71-9253

Department of Energy

**Responses to NRC Request for Additional Information
April 4, 2001**

CONFIGURATION 1 - "-85" DESIGNATION

Figure 1
Location and Geometry of Aluminum Spacer Sleeve

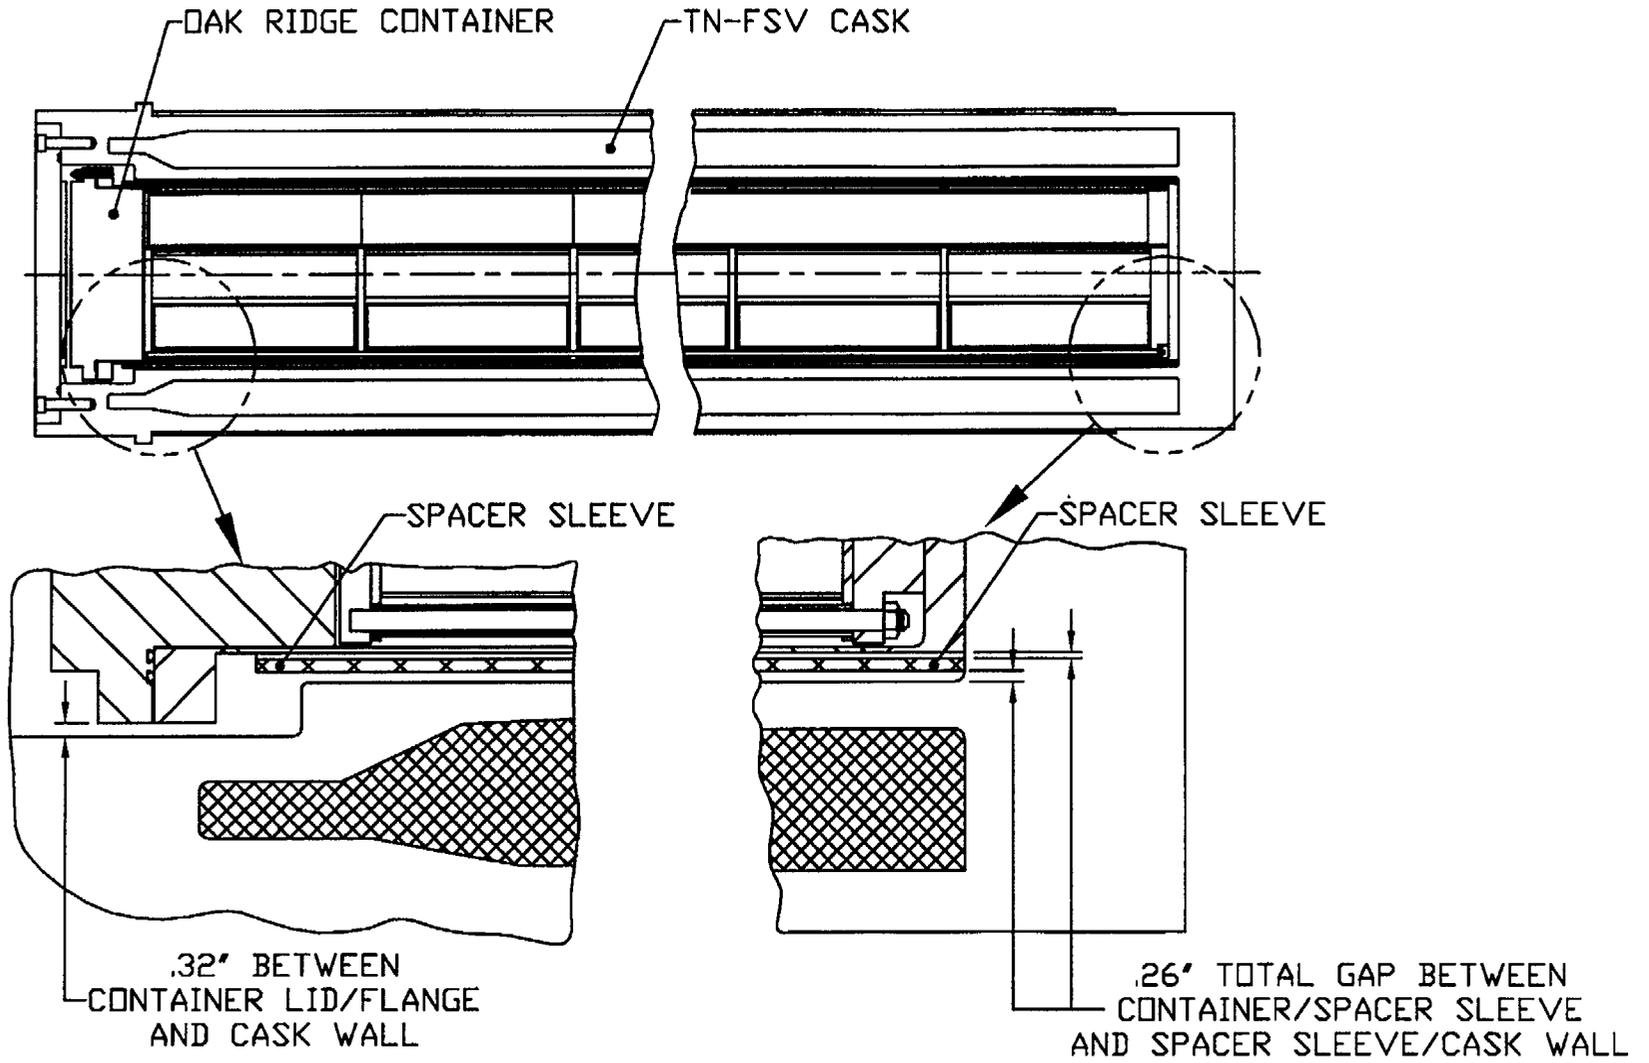
- 2-9 Describe the function of the spacer sleeve (Item No. 30 in the Parts List on Drawing No. 3044-70-1) and the method of attachment to the Oak Ridge Container, if any.

Drawing No. 3044-70-1, Rev.0, shows the spacer sleeve on the outside of the container. The function of the sleeve and the method of attachment to the container shell are not addressed in the application or the packaging drawings. This information addresses the requirements of 10 CFR 71.33.

Figure 1 depicts the location and geometry of the aluminum spacer sleeve. The 0.32 in. gap between the container lid and the TN-FSV Cask wall inner surface, as well as the 0.26 in. gap between the aluminum spacer sleeve and the cask wall inner surface are clearly shown.

Figure 2.11.1-1
Free Body Diagram of Oak Ridge Container
Subjected to a Vertical or Near Vertical Lid End Drop

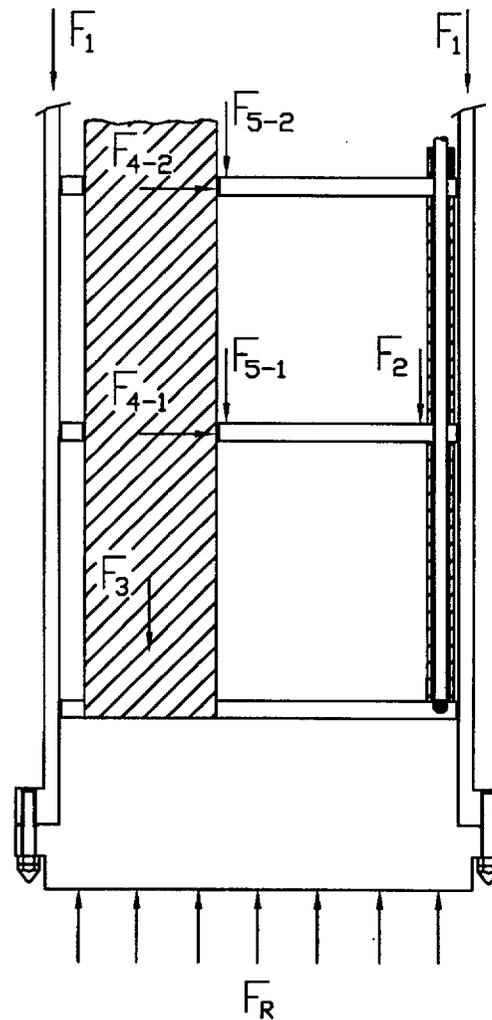
2-1 Revise the analysis for the standoffs to consider the weight of the canisters and the fuel assemblies.

Section 2.11.1.2A evaluates the structural adequacy of the standoffs for normal and accident condition events described 10 CFR Part 71. For computing the stresses in standoffs, self-weight, and the weights of poison plates, poison enclosures, and support discs, are used in calculating inertia loads during an end drop accident. However, the weight of the canisters and the spent fuel is not considered. Even though this assumption may be applicable for a perfectly vertical end drop, it will not be correct for a potential drop at any other angle. The inertial loads from the canisters should be considered in the analysis of the standoffs due to an end drop accident. Alternatively, justify why the weight of the canisters and fuel assemblies is not considered in this evaluation. This information addresses the requirements of 10 CFR 71.33.

During the vertical lid end drop (see Figure 2.11.1-1), the support disc and poison enclosure (including poison plates within the enclosure) nearest to the impact bear directly on the inner surface of the container lid for the lid end drop (or inner surface of the container bottom plate for the bottom end drop – see Figure 2.11.1-2). The standoffs do not carry this inertial load. Therefore, for the end drop analysis, the inertial loads of the support disc and poison enclosure with poison plates nearest to the impact, are not included in the axial compressive load applied to the standoffs.

Since the fuel compartments, canisters, and flux traps also bear directly on the inner surface of the container lid during a lid end drop (or inner surface of the compartment spacer, which bears directly on the container bottom plate for the bottom end drop), their loads are also not included in the compressive load applied to the standoffs.

In order to bound the potential effects of the inertial load of the fuel compartments, canisters, and flux traps during a near vertical drop, an additional corner drop analysis is added to Appendix 2.11.1 of the application.

Appendix 2.11.1 has been revised accordingly with the addition of free body diagrams.

Figure 2.11.1-2
Free Body Diagram of Oak Ridge Container
Subjected to a Vertical or Near Vertical Bottom End Drop

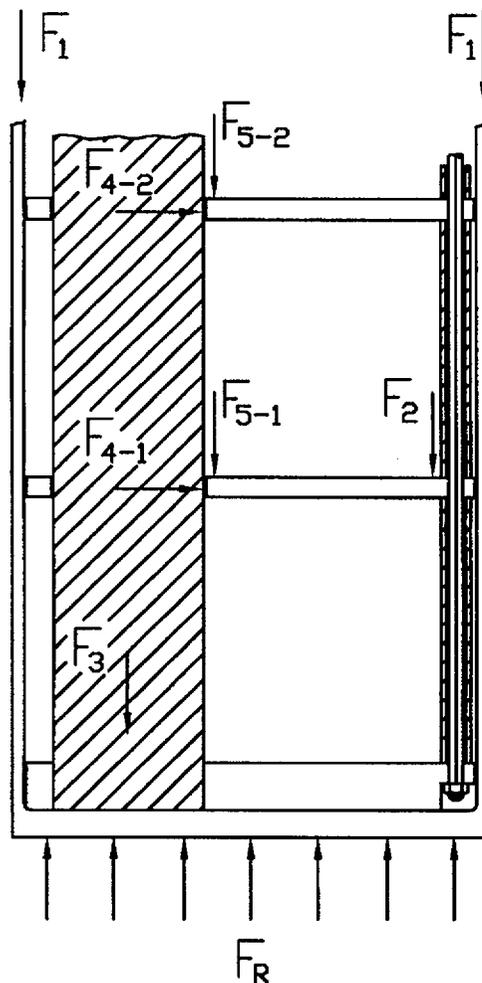
- 2-6 Revise the analysis of stresses in the Oak Ridge Container shell and top and bottom plates to include the weight of the canisters and spent fuel due to an end drop accident, as shown in Section 2.11.2.2 (pages 2.11.2-3 and 2.11.2-8) of the application.

A free body diagram of the bottom end drop, Figure 2.11.1-2, has been added to the Addendum. The reaction force, F_R , shown in Figure 2.11.1-2 represents the uniform support provided by the TN-FSV Cask bottom plate. The inertial load, F_1 , which represents the inertial loads of the Oak Ridge Container shell, flange, and lid, is used to calculate the maximum compressive stress in the Oak Ridge Container shell during the bottom end drop.

Figure 2.11.1-3
Free Body Diagram of Oak Ridge Container Fuel Basket
Subjected to a Side Drop

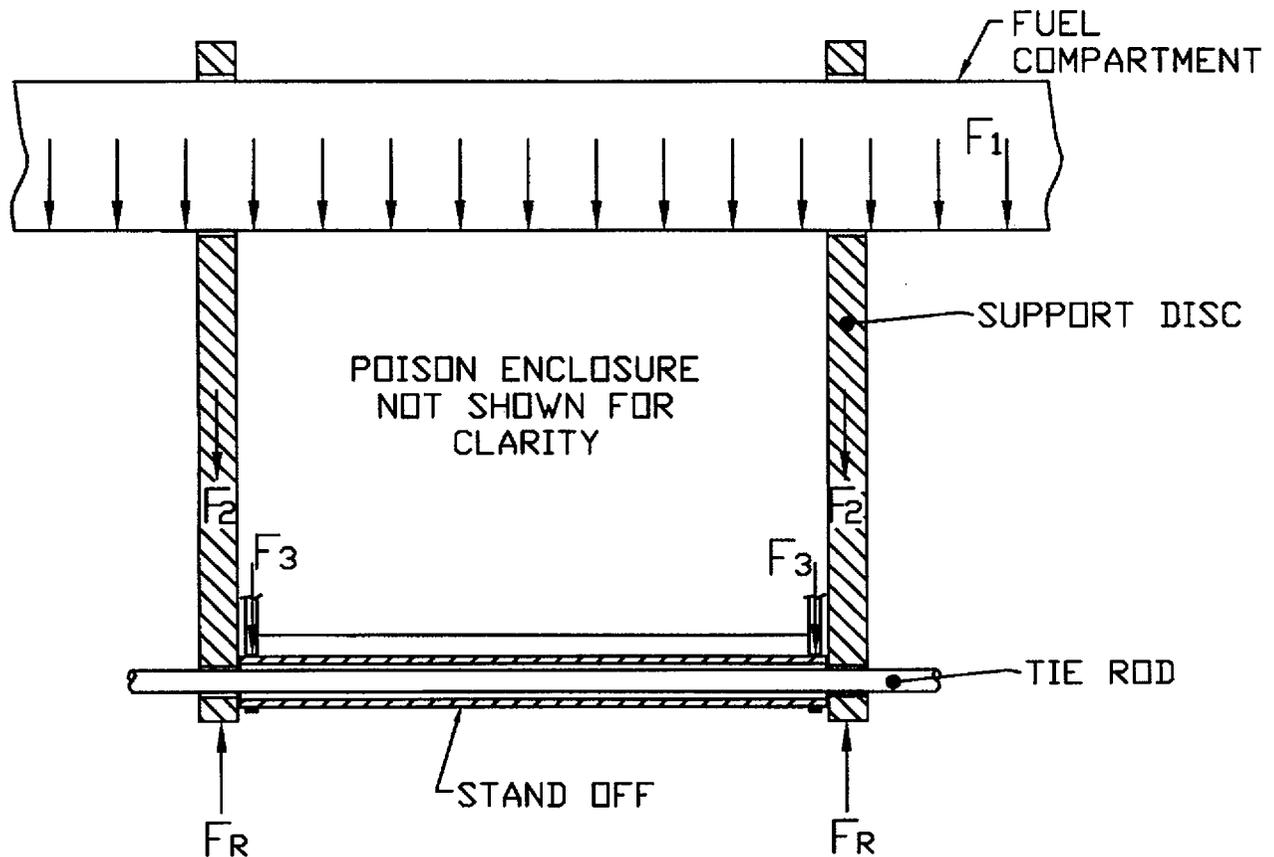
- 2-2 Revise the analysis of the standoffs to include consideration of a 30-foot side drop.

Section 2.11.1.2A evaluates the structural adequacy of the standoffs. This section addresses the load on the standoffs during an end drop accident, but does not address the behavior during a side drop accident. Alternatively, justify why the side drop accident was not considered. This information addresses the requirements of 10 CFR 71.33.

- 2-3 Revise the analysis of the side drop accident to consider bending stresses in the tie rods.

Section 2.11.1.2F evaluates the structural adequacy of the tie rods. This section addresses the loads on the tie rods during a side drop accident, and considers the shear stresses at the support discs. However, the bending stresses in the tie rods are not addressed. Alternatively, justify why the bending stresses in the tie rods are not considered for the side drop accident. This information addresses the requirements of 10 CFR 71.33.

During a side drop event, the standoffs and tie rods are subjected to their own inertial load plus the inertial load of the poison enclosures and poison plates (see Figure 2.11.1-3). The tie rods are supported by the transverse reaction force of the spacer discs. This reaction force generates shear stresses in the tie rods at the spacer disc locations, and bending stresses in both the tie rods and standoffs between the spacer discs. Consequently, shear stress generated in the standoffs, during a side drop event, is negligible. Bending stress in both the standoffs and the tie rods is computed in the tie rod analysis section below (see Response to question 2-3).

Figure 2.11.1-3 is a free body diagram of the fuel basket during a side drop event. The figure shows that the only loads applied to the tie rods are the inertial load of the poison enclosures, F_3 (acting near the support disc locations), and the inertial loads of the standoffs and tie rods themselves.

The tie rod analysis, Section 2.11.1.2.F of the Addendum has been revised to show the additional analysis.

Figure 2.11.1-4
Free Body Diagram of Oak Ridge Container
Flux Trap Subjected to a Lid End Drop

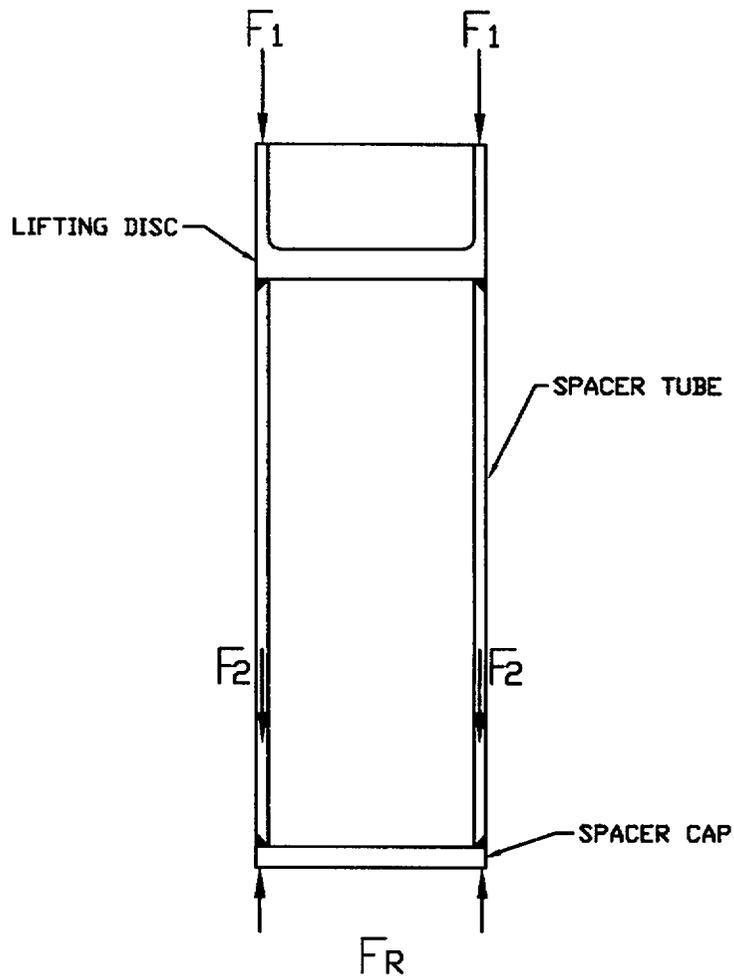
- 2-10 Revise the structural analysis to address the adequacy of the top and bottom plates of the flux trap for normal and accident condition events (10 CFR 71.71 and 10 CFR 71.73).

The analysis is added to the flux trap spacer section of Appendix 2.11.1 in the Addendum.
